**GOVERNMENT  
ARCHITECT NSW**

**FEEDBACK AND  
RESPONSE REGISTER**

Ref	Design Area	SDRP Session & Panel Feedback	Response	Report / Design Reference
	SDRP Session 4: 31.07.2019 (Developed Schematic Design)			
		Since SDRP03, the panel recognises internal clinical planning has been the focus of the design process, resulting in significant changes to the planning of the hospital. The following issues have arisen from updated internal planning:	/ The final stages of Schematic Design has involved clinical planning, budget and design consolidation. / This process has required the review and rationalization of the building form and briefed area to ensure functionality and optimum cost efficiencies are achieved. / This has resulted in a rationalized building form that reflects the project brief and budget

Figure 112. Floor Plan - Lower Ground Level, Block & Stack

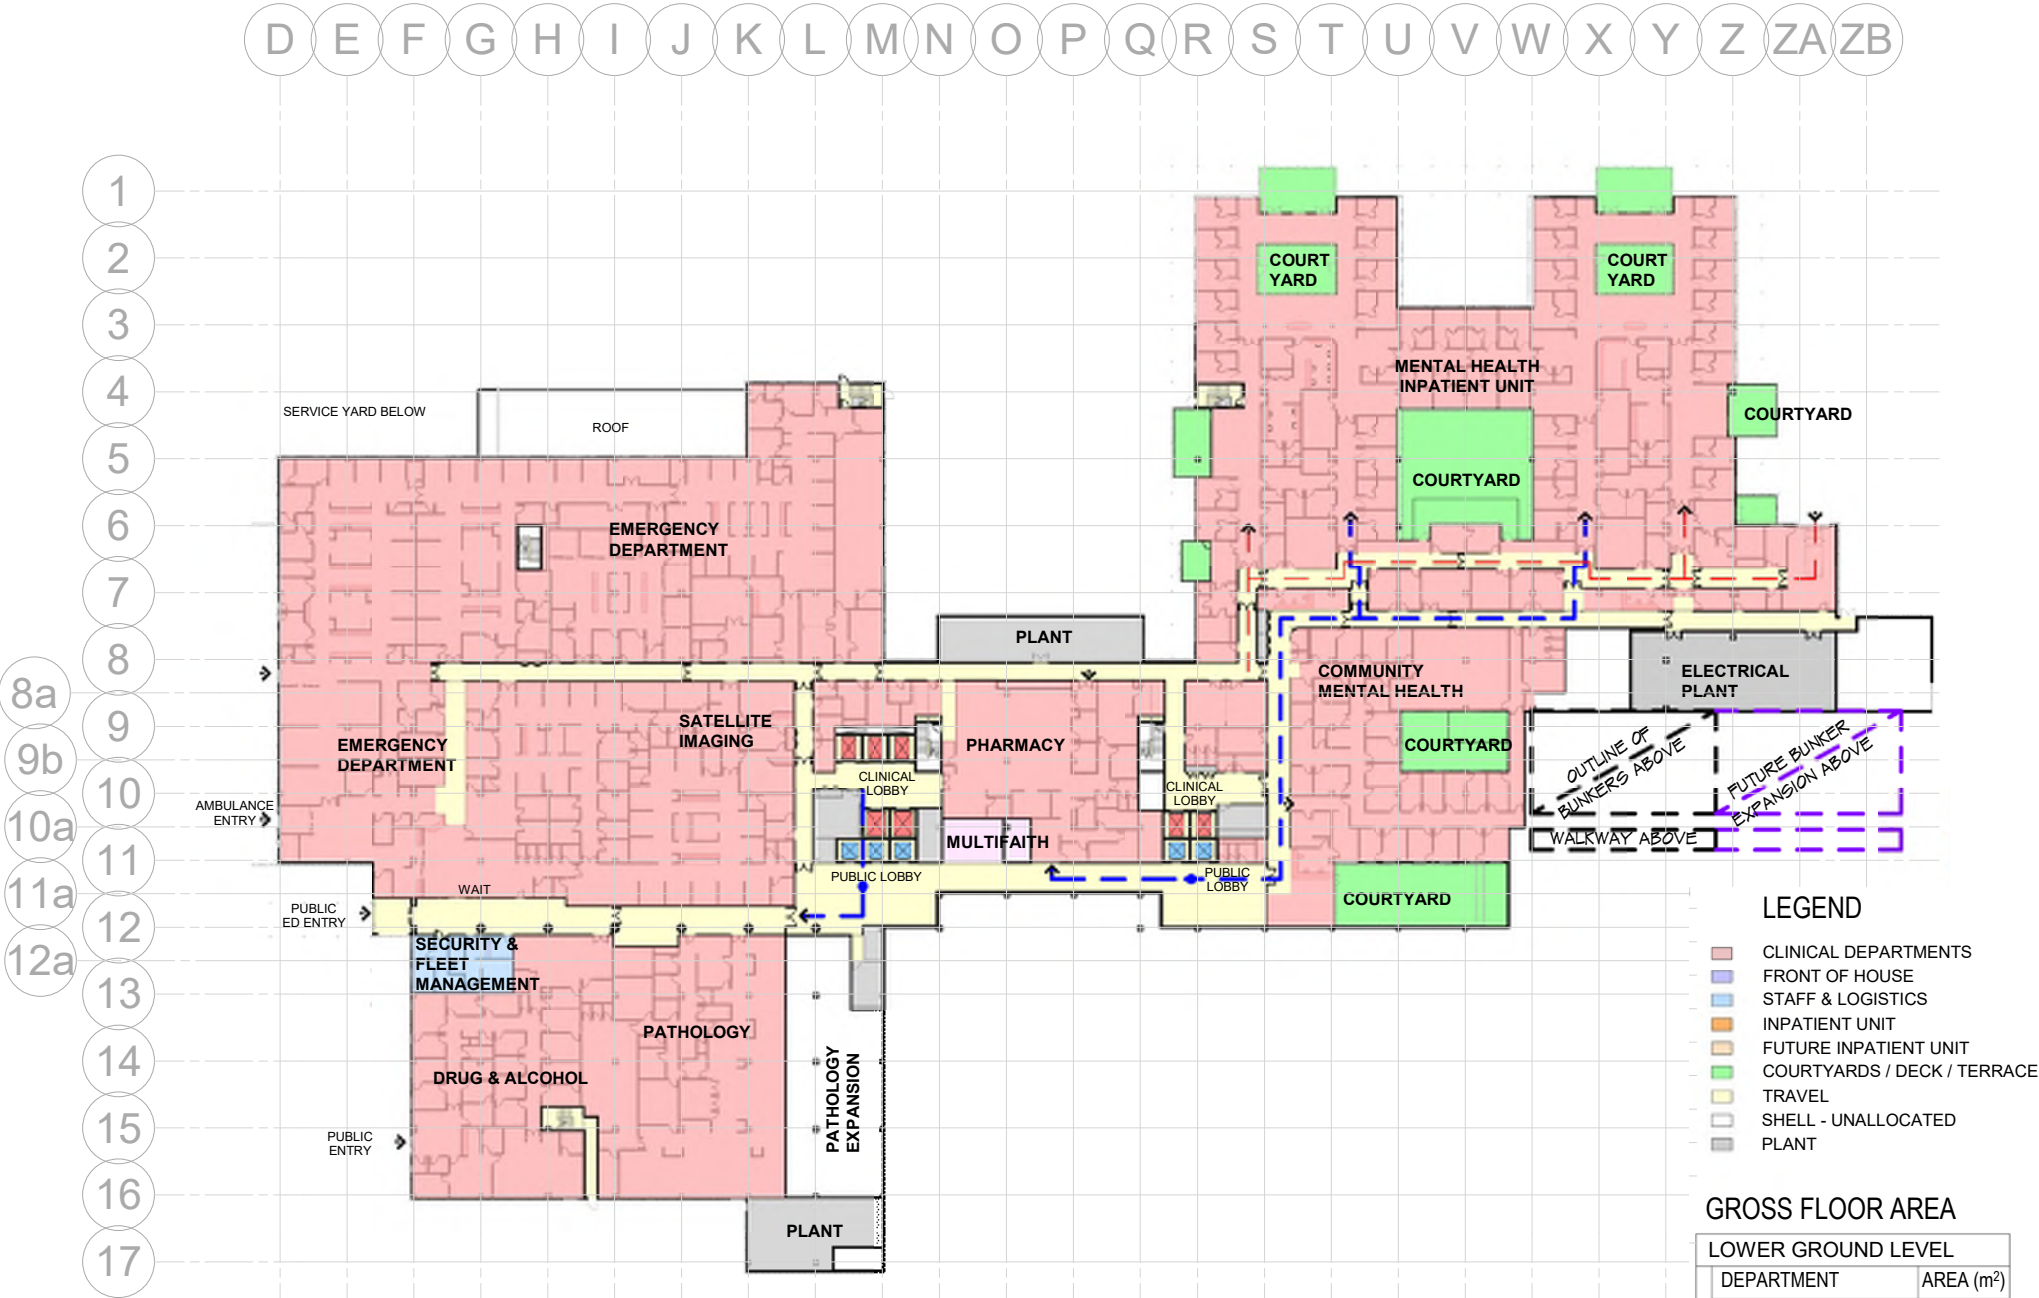
4.2	Architecture	Loss of the north west internal courtyard on the lower ground floor and associated light voids on the ground level and level 1	/ As per 4.1, necessitated by clinical planning requirements at level 1.	Refer section 6.1

4.3	Architecture	Long, narrow corridors on the lower ground floor lacking in natural light	/ As a result of the Multi-Deck Carpark being located to the west of the hospital, it is recognised that the lower ground west Emergency Department entrance will serve as an important public entry point to the hospital. Design option studies have been prepared to develop and refine the lower ground floor entry experience and journey to ground level. Various options have been considered to establish spatial relief and amenity to support the user journey experience to the west stair/lift core which will bring the visitor to the main ground level foyer and reception. Design strategies include: 1. Materiality and treatment which reflects the main entry lobby of the hospital 2. An episodic journey curated through periodic corridor widening, ceiling height modulation 3. Introduction of wall murals (art), a refined ceiling design incorporating feature lighting and glazed walls serving to expand spatial perception at key sections of the journey. 4. Increase in size of the void connecting the lower ground floor lift lobby to the ground floor lift lobby providing visual connection through to the main entry lobby of the hospital.	Refer section 5.2 and 6.1

4.4	Architecture / Landscape	The reduction in size of the north east internal courtyard on the lower ground floor	/ The reduction in north east courtyard is necessitated to ensure a compact clinical design, minimizing horizontal travel where possible. Design of the courtyard will include landscaping to provide natural relief for internal overlooking spaces and public realm amenity. Views to surrounding landscape (external to the building) have been exploited where permissible while preserving clinical functionality.	Refer section 6.1

Figure 115. Floor Plan - Level 2, Block & Stack

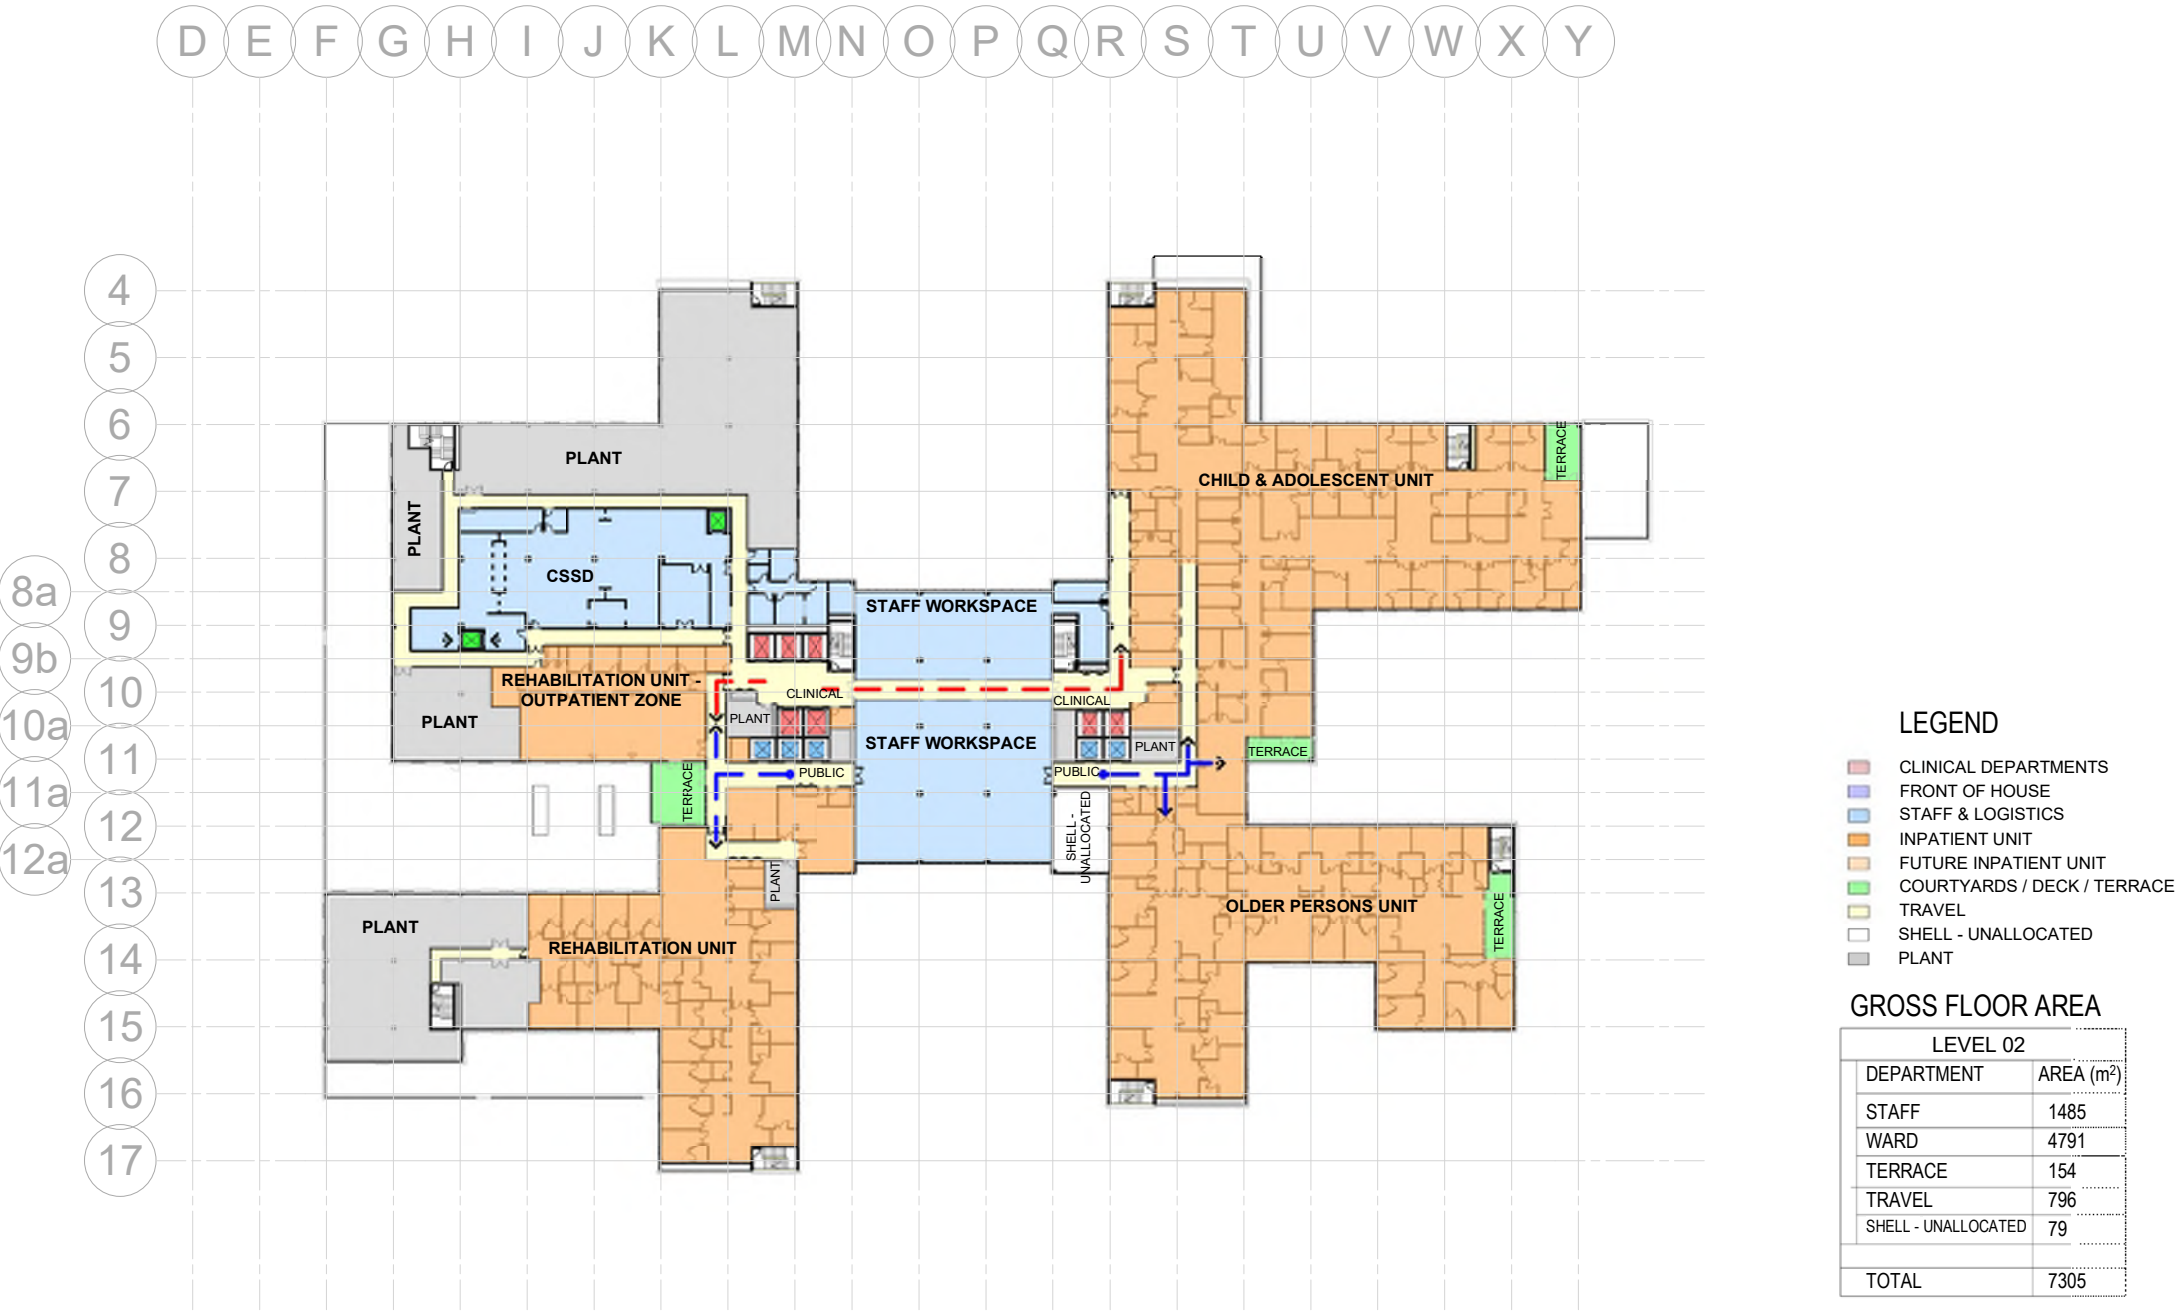
4.5	Architecture	Loss of sky gardens to the north west and north east of the shared administration area on level 2	/ Balconies ("sky gardens") have been provided in support of co-share admin area located at levels 3 and 4. The shared admin area is designed to function as shared collaboration space in anticipation of inter-departmental cooperation. The central clinical lift lobby stairs will be developed to be visible and attractive alternatives to the lifts, encouraging staff to access levels on foot, including access to shared staff balcony areas at levels 3 and 4 (limited to one floor up or one floor down).	Refer section 6.1

4.6	Architecture	50% (approx.) reduction in size of the level 2 Child & Adolescent and Older Persons IPU sky garden	/ Balconies serving the named level 2 departments have been aligned with the design brief and optimized to serve functional requirements	Refer section 6.1

Figure 116. Floor Plan - Level 3, Block & Stack

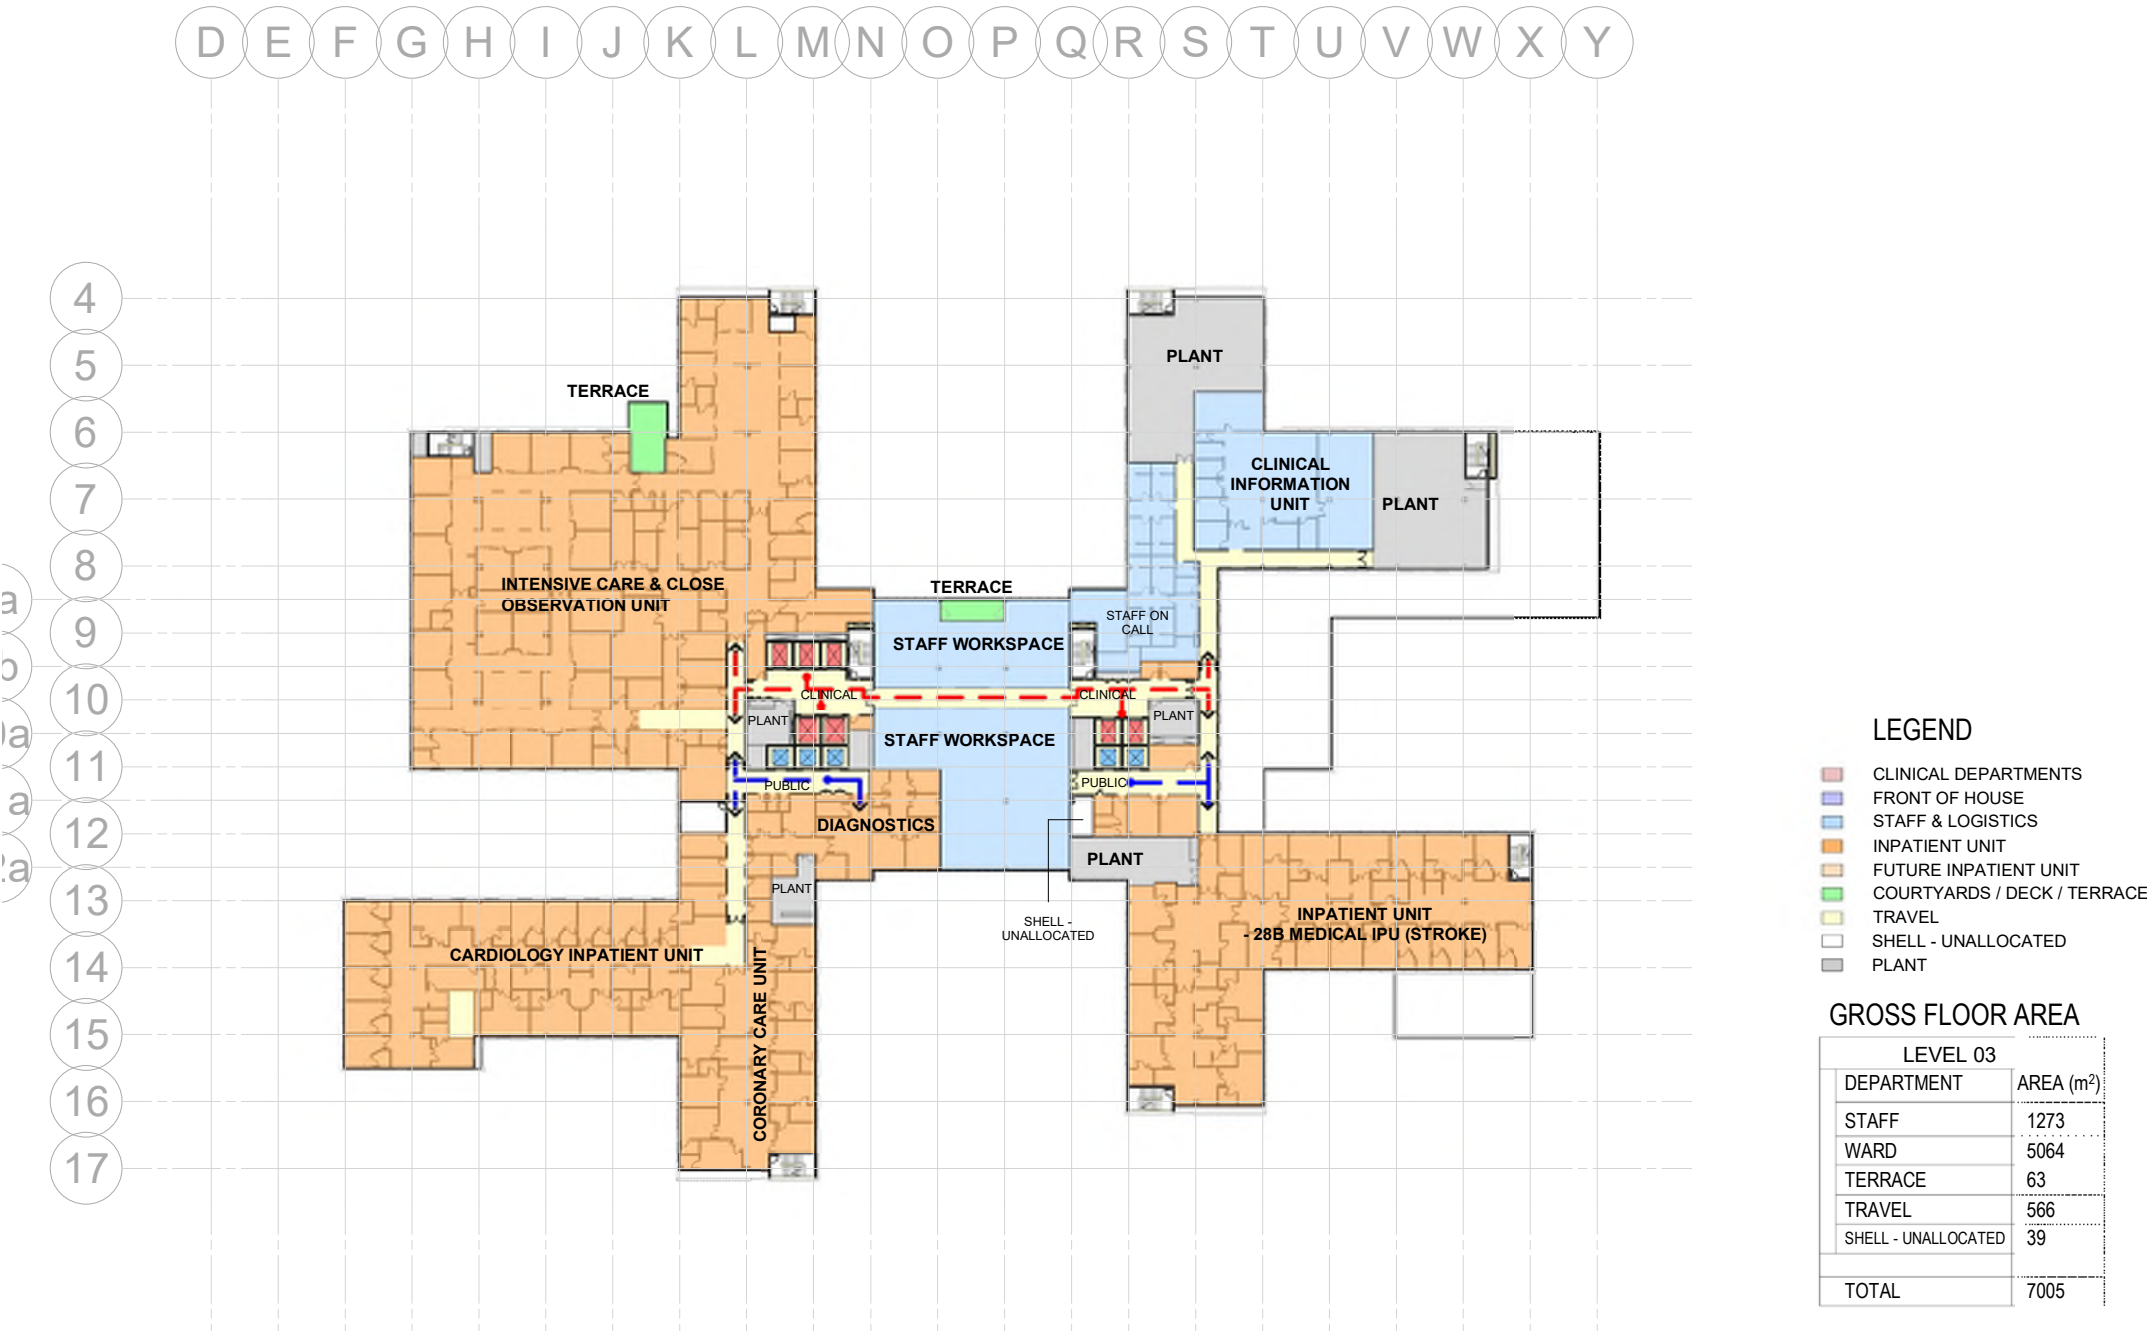
4.7	Architecture	Loss of the sky garden to the north west of the shared administration zone on level 3	/ A staff balcony has been re-introduced to the north west co-share admin zone at level 3.	Refer section 6.1
